Data Request Response #4

Corby Battery Energy Storage System Project (24-OPT-05)

October 2025

Figure 2-1: Alternative Sites
Location Map

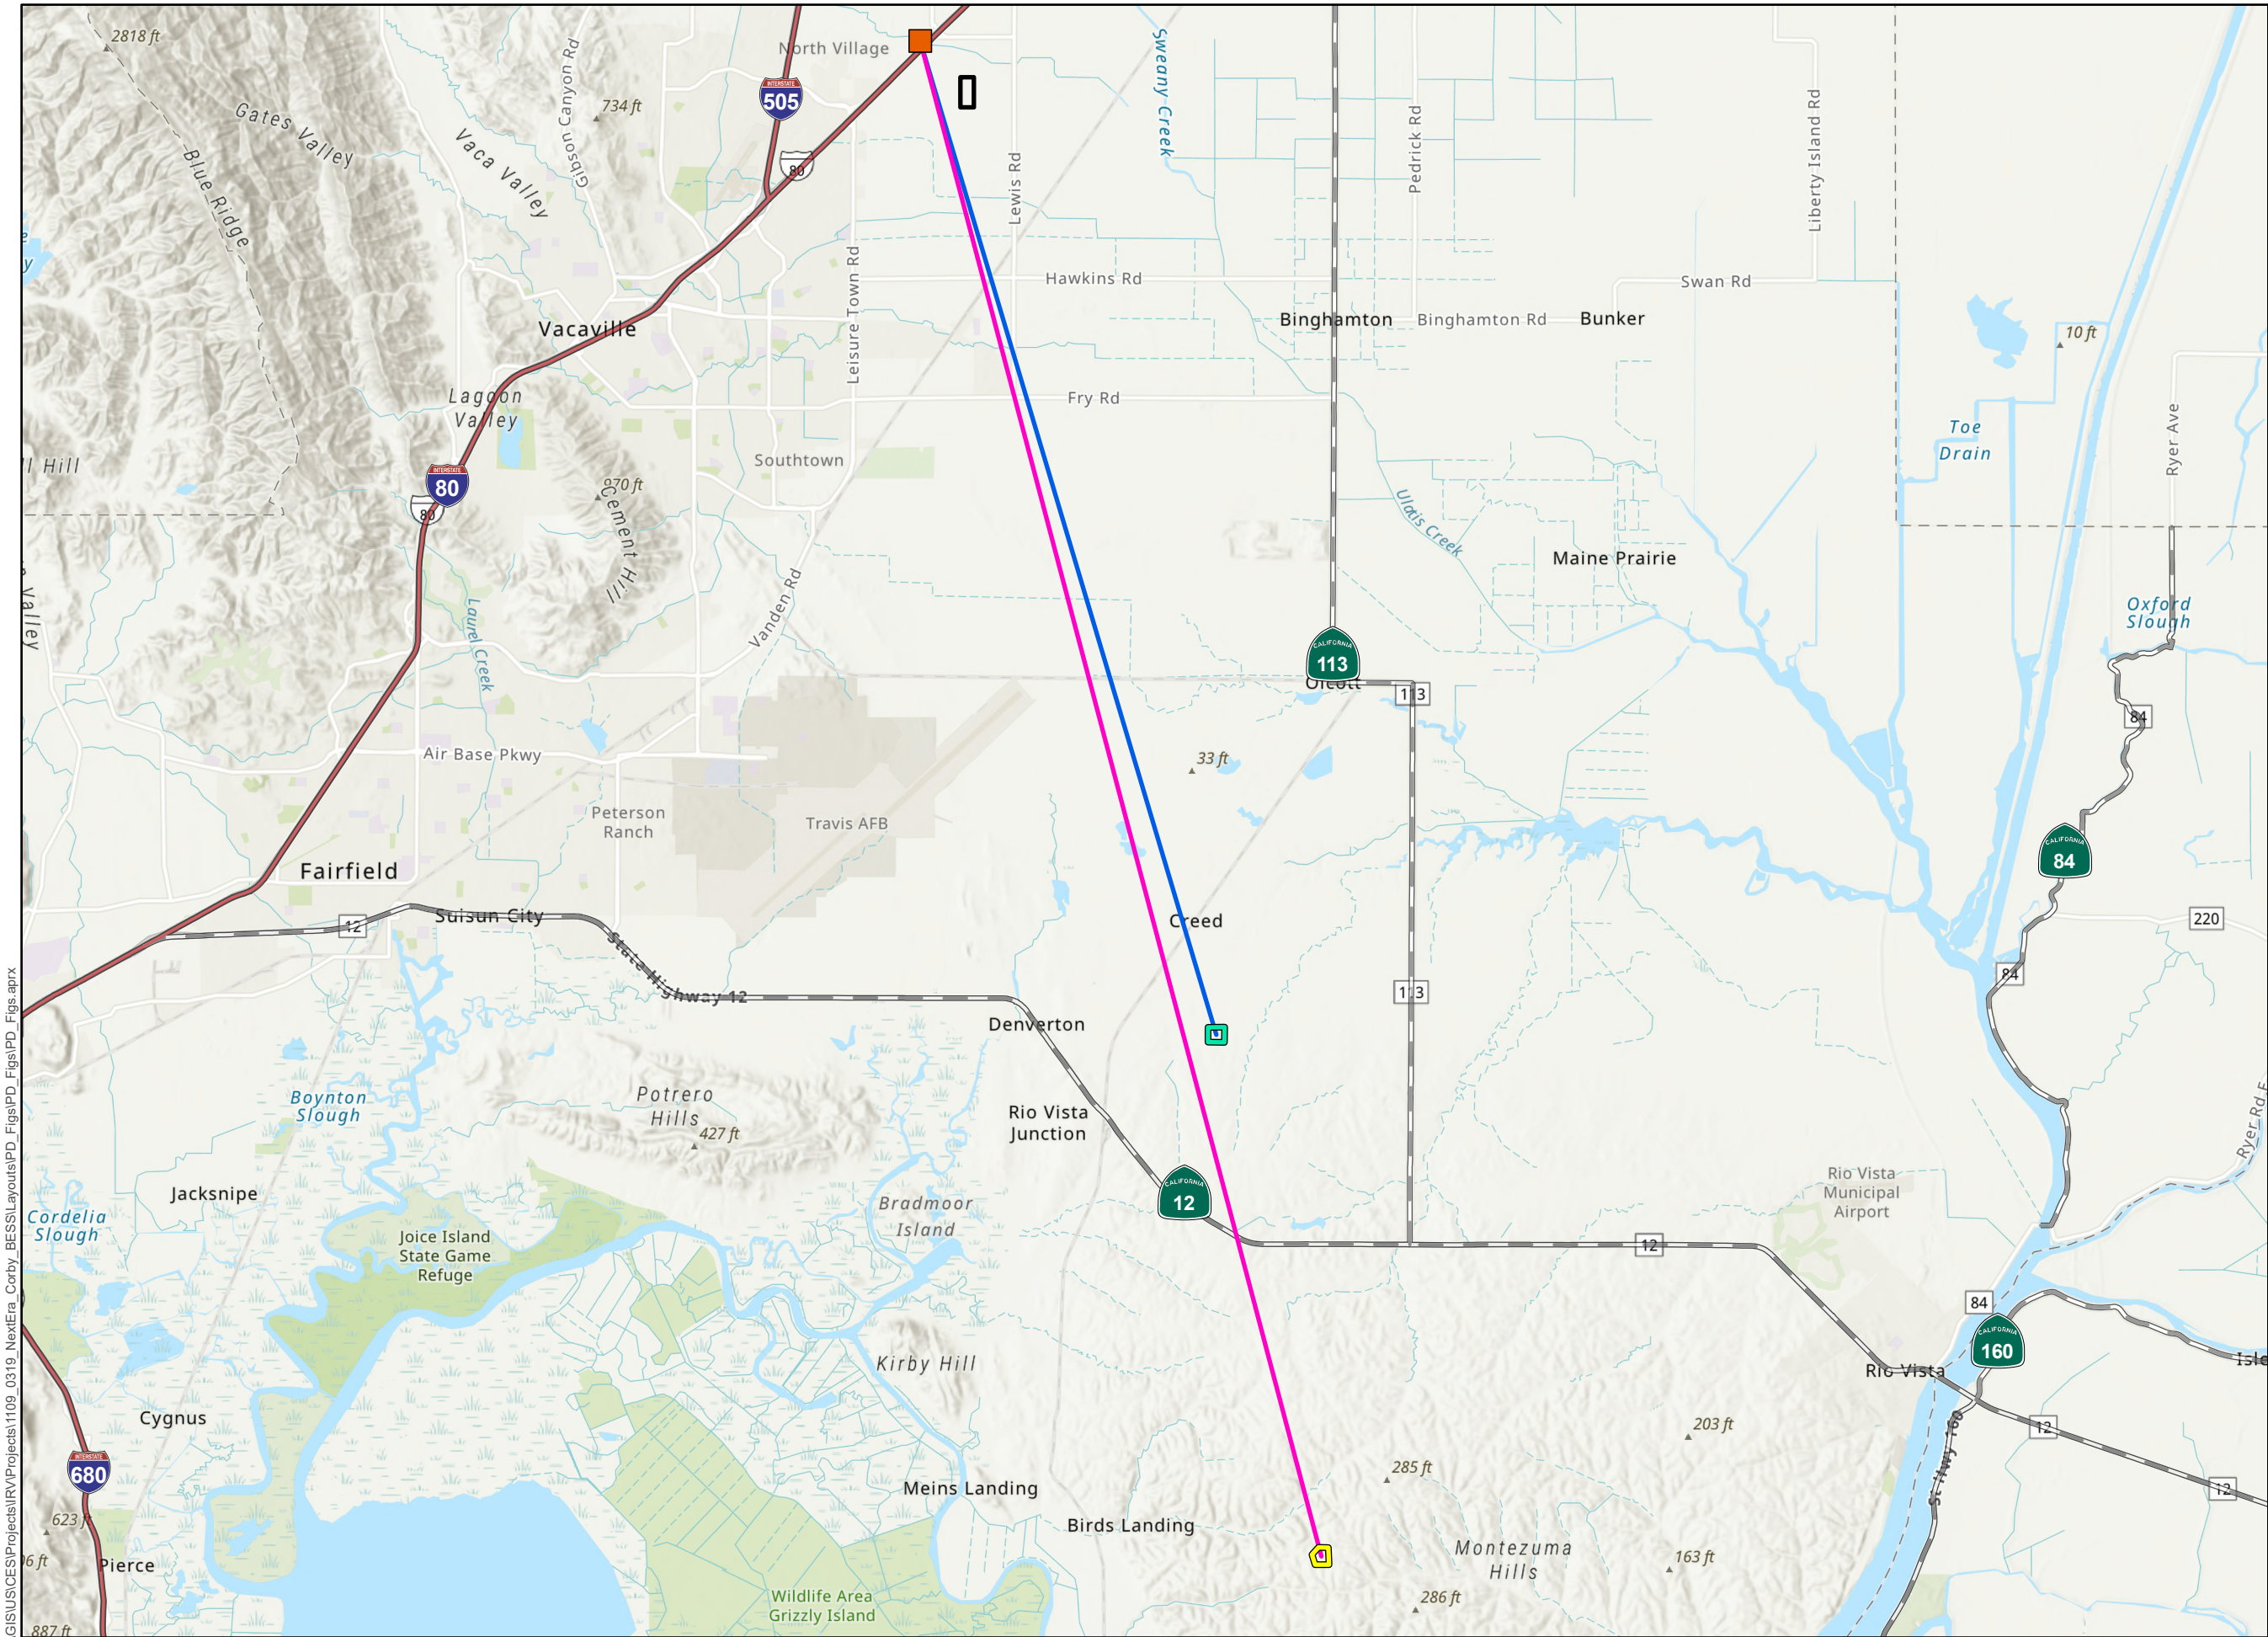
REV 2 DR ALT-2. Please provide the information below for each of two alternative project sites in southern Solano County being considered: (1) Lambie Industrial Park, and (2) Montezuma Wind Energy Center:

- a. A map illustrating the alternative site location;
- b. Size (acreage and megawatt capacity) of a BESS facility that could be constructed;
- c. Details on project components including access roads, substation/switching station, generation tie (gen-tie) line, and ancillary facilities;
- d. How the site meets the project objectives; and
- e. Any other site considerations that would facilitate or inhibit the development of a BESS.

- a. The following new figures have been prepared depicting potential alternative sites at the Lambie Industrial Park and Montezuma Wind Energy Center:

- Figure 2-1: Alternative Sites Location Map
 - Figure 2-2: Lambie Industrial Park Alternative Site
 - Figure 2-3: Montezuma Wind Energy Center Alternative Site

- b. Each of these two alternative sites would be approximately 25 acres, which would be sufficient to construct a BESS facility of similar size and capacity to the proposed Project (300-MW, 1,200-megawatt-hours).

Figure 4
Corby BESS Thermal Runaway Source Locations

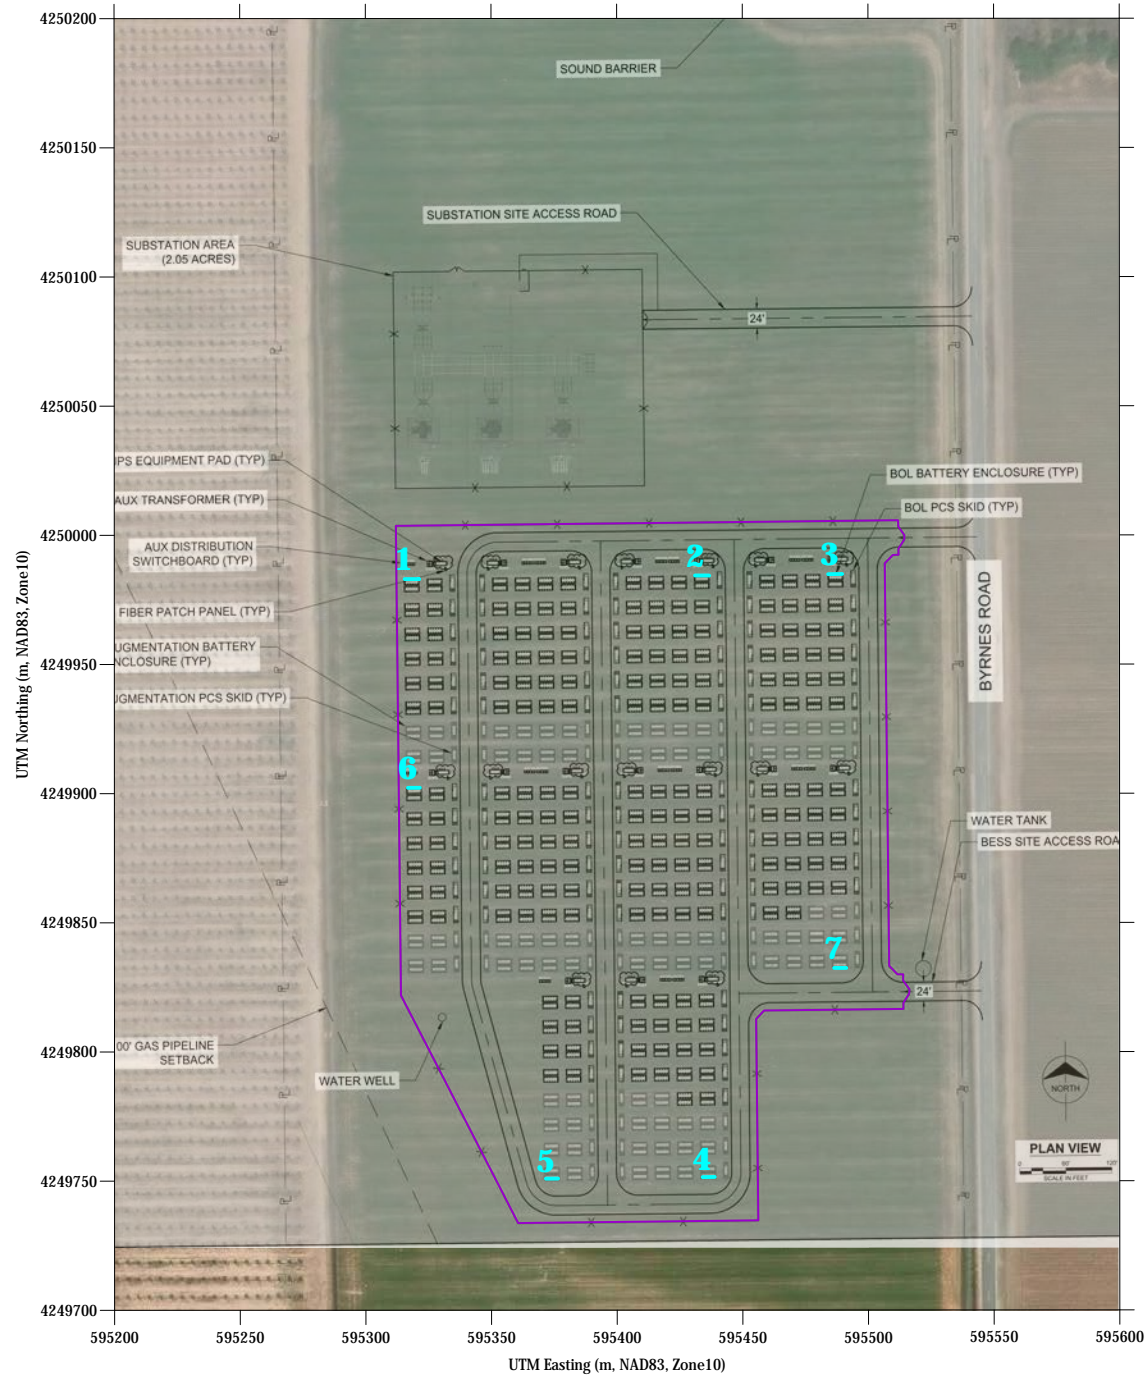
REV 1 DR WS/FP/PH-1. Please provide the exact locations (latitude and longitude or UTM coordinates) and dimensions of the BESS enclosures for modeling purposes. Please provide the following input parameters for a dispersion modeling analysis of all potential criteria air pollutants, greenhouse gases, and toxic air contaminants (TACs) that could be generated during combustion: emission rates (in grams/second), exhaust temperature, pressure, and exhaust gas velocity resulting from battery damage or thermal runaway/fires. Please also provide detailed calculations and justification for parameters used in the calculation of the air pollutant density values. Please include the calculation worksheet if available.

Response: The AERMOD dispersion model input and output file will be supplied to CEC Staff. The modeling input file has the locations of the seven modeled BESS enclosures in Universal Transverse Mercator (UTM), North American Datum 1983 (NAD83), Zone 10 coordinates. The modeling file was used to support the technical report that is included in Appendix 3-A. Additionally, the emission rates and exhaust parameters are included in the technical report and modeling files. Working calculation sheets will also be provided to CEC Staff.

Given that the hypothetical thermal runaway event and resulting fire could occur at any of the battery containers located within the 40-acre project site, seven (7) locations were selected based on the proximity to sensitive receptors and roadways. These locations were selected in part to determine the potential for worst case off-site modeled concentrations. Figure 4 presents these locations.
